AGENDA
Planning and Zoning Commission
August 3, 2022 – REGULAR MEETING

Meeting Date:	August 3, 2022	Meeting Title:	Planning Commission
Submitting Department:	Planning Department	Presenter:	Tyler Valentine
Agenda Item:	P22-134 Conditional Use Permit for the Fairgrounds Community Center at the property addressed at 305 W. Snow King Avenue	Public Comment:	Yes

Meeting Date:	August 3, 2022	Meeting Title:	Planning Commission
Submitting Department:	Planning Department	Presenter:	Katelyn Page
Agenda Item:	P22-144 Development Plan for a new 3-story, residential building at the property addressed 80 E. Karns Avenue	Public Comment:	No

Sheet title:
FAR BREAKDOWN

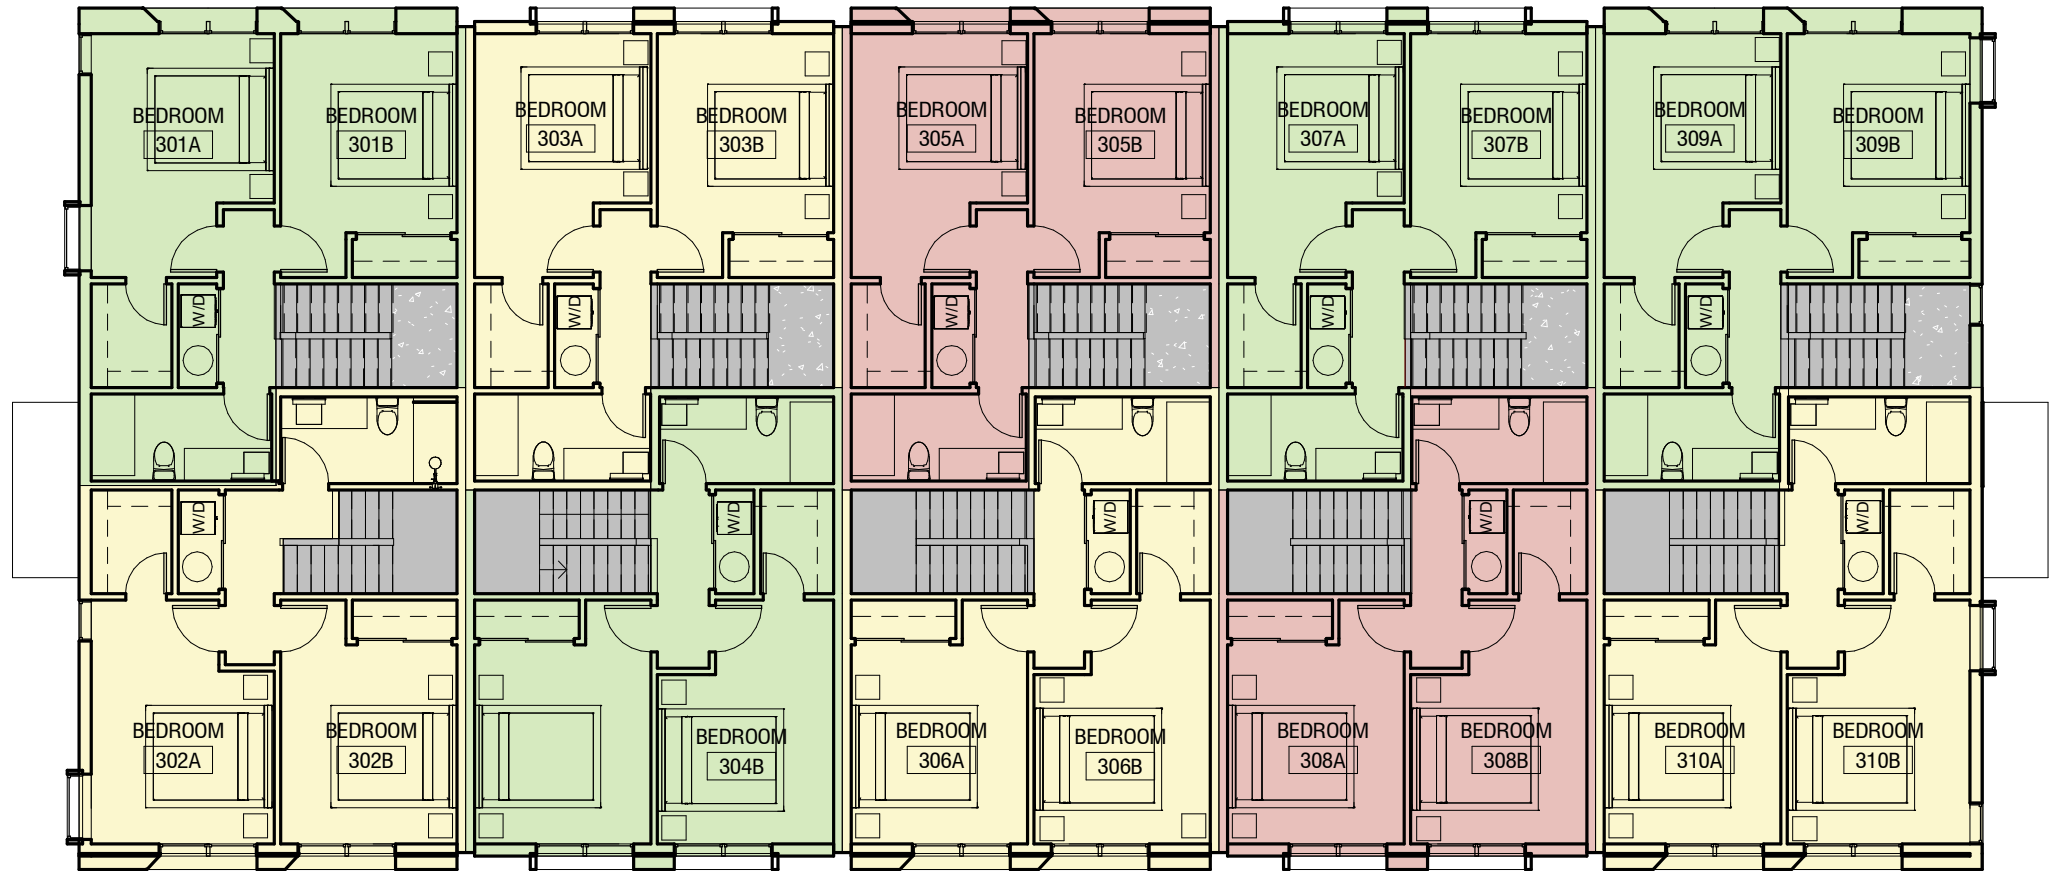
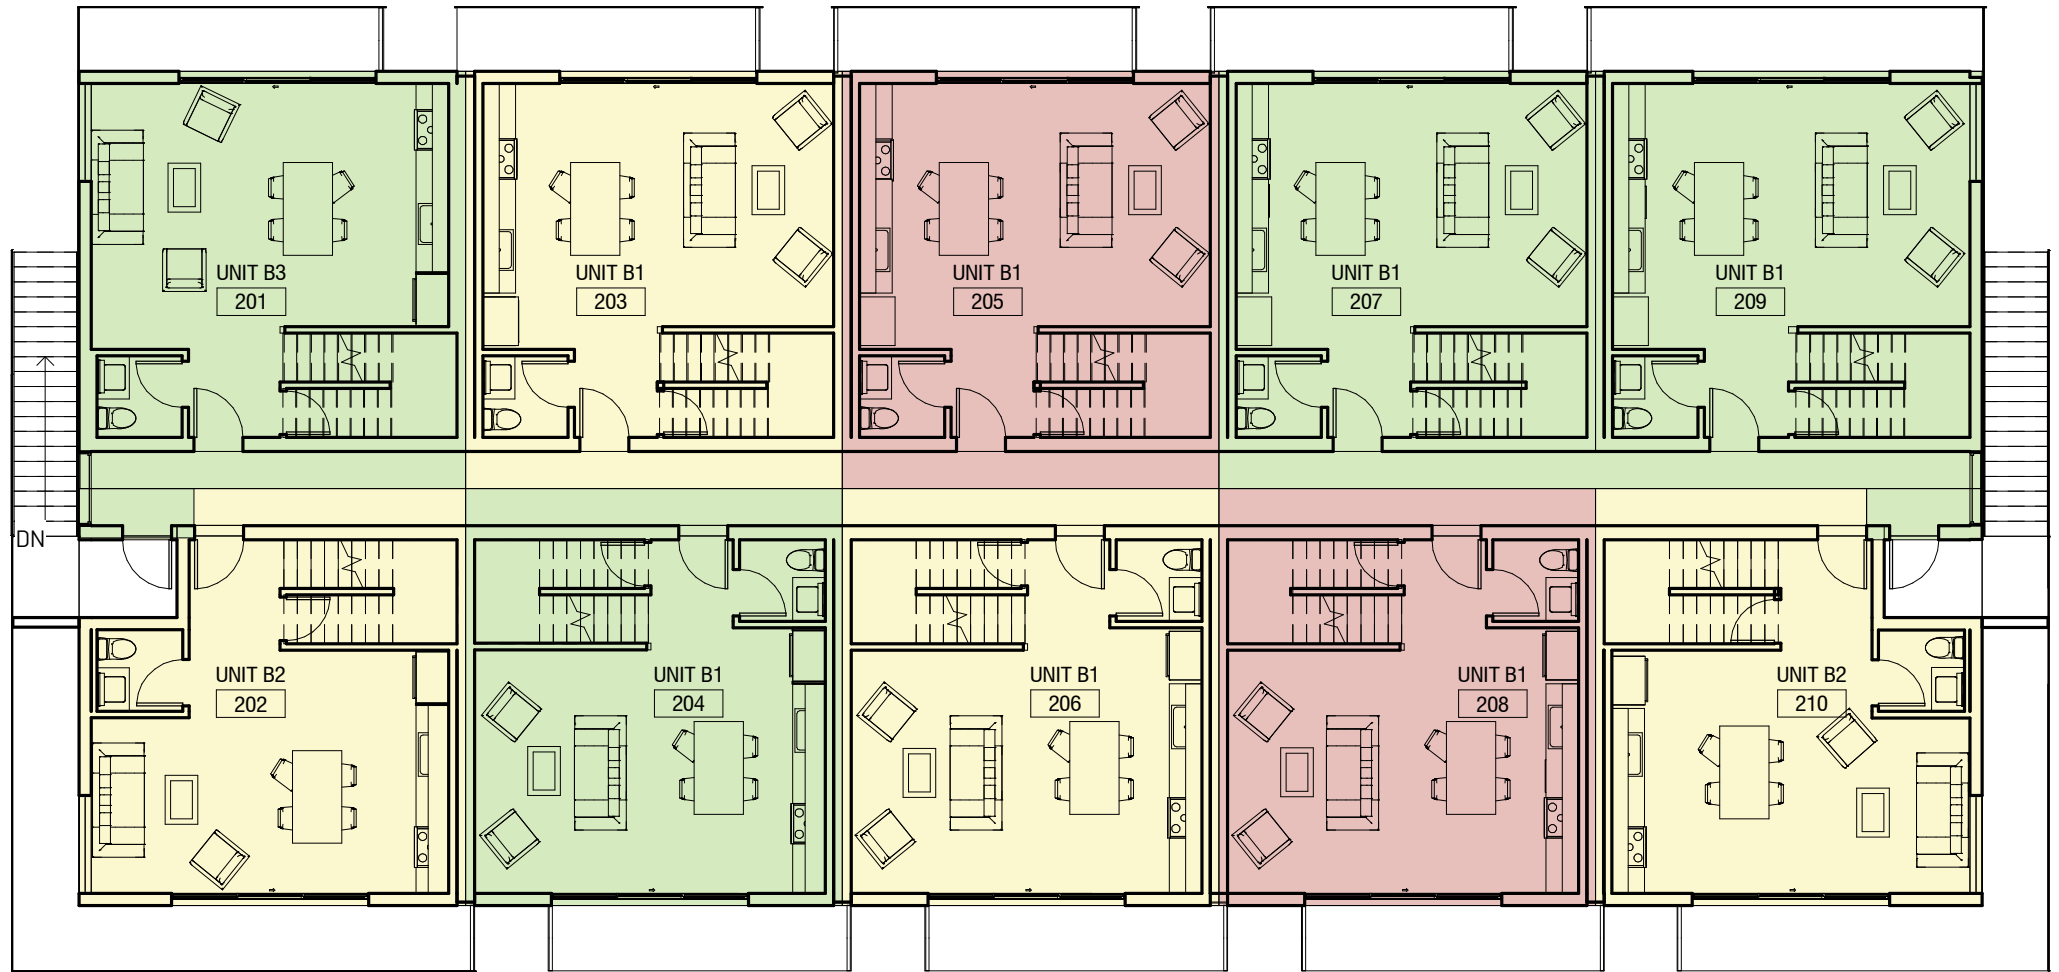
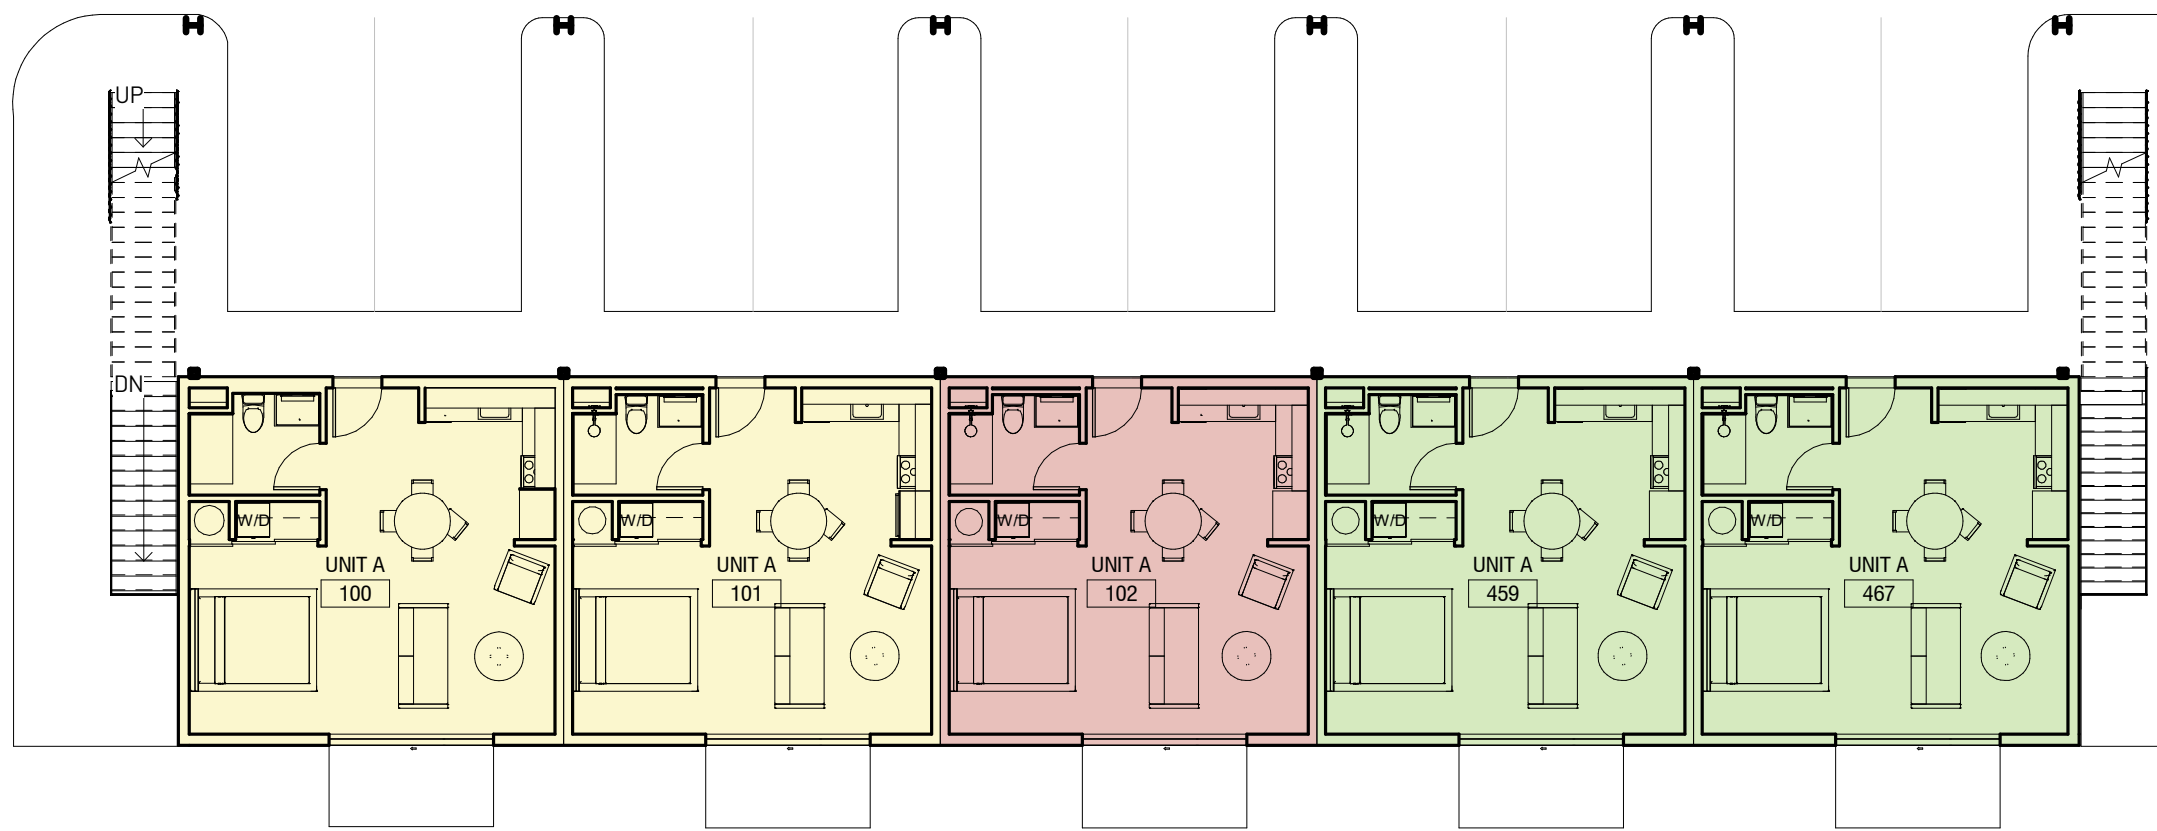
During Staff review of project, it was discovered that floor area had been defined incorrectly. Staff directed design team to recalculate how floor area was defined on plans based on the Town's LDR definition of floor area as measured to the exterior face of the structural members of the wall rather than to the interior face of the wall. While this has not impacted the gross SF of the overall building, this recalculation impacts final calculations for habitable floor area, application of the Workforce Housing Floor Area Bonus, and parking requirements. Staff has noted these impacts in the below sections and an updated FAR exhibit has been included in meeting packet.

Site Plan

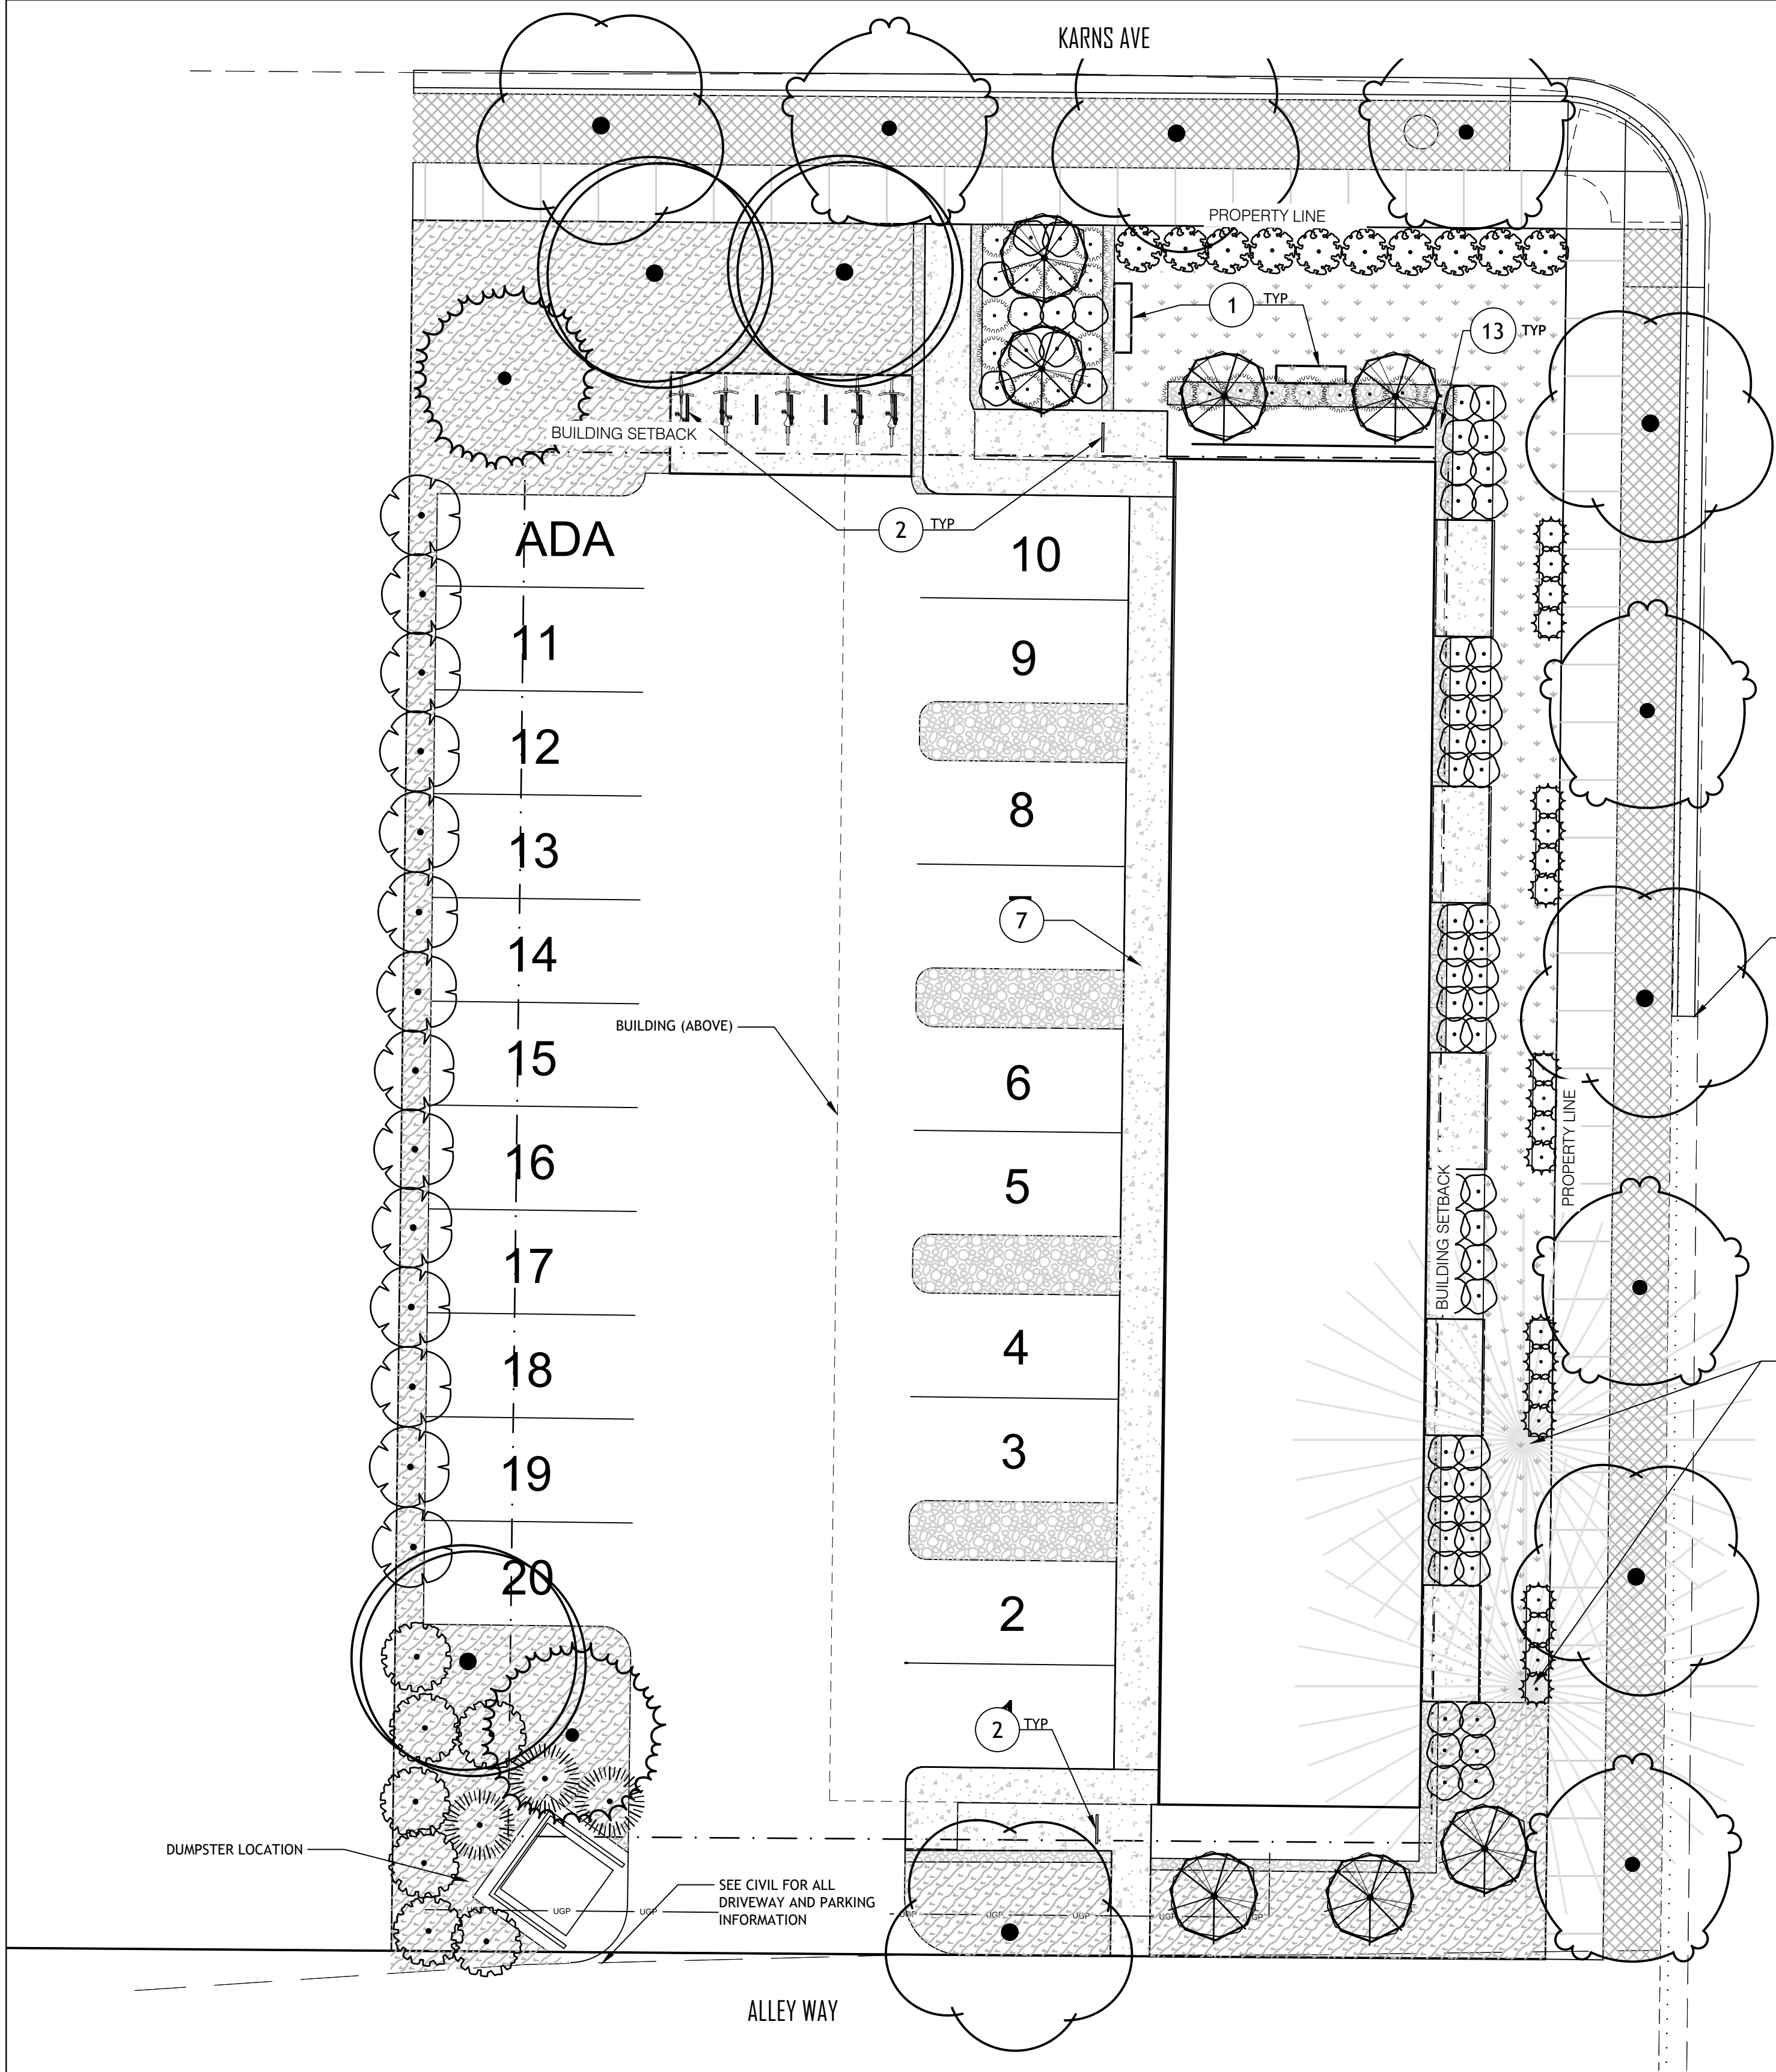
1. Prior to submittal of a building permit, applicant shall revise site plan to show covered parking places as 18' deep with wheel stops 2' before covered sidewalk and uncovered parking places as 20' deep with wheel stops 2' before landscape strip.
2. Prior to submittal of a building permit, applicant shall revise site plan to show drive aisle width of 21'.
3. Prior to the project appearing before Town Council, applicant shall meet minimum parking requirement through building design or Administrative Adjustment.

1. Provide minimum six feet wide sidewalks in front of 18-foot deep parking spaces.
2. Provide ramps and accessible routes compliant with the LDRs and IBC.

3. Street trees shall be spaced 30-40 feet on center per LDRs 2.2.C.3 on pedestrian frontage.
4. Project shall provide accessible parking, parking and traffic control signage and curb markings. Provide a striping and signage plan with permit application.
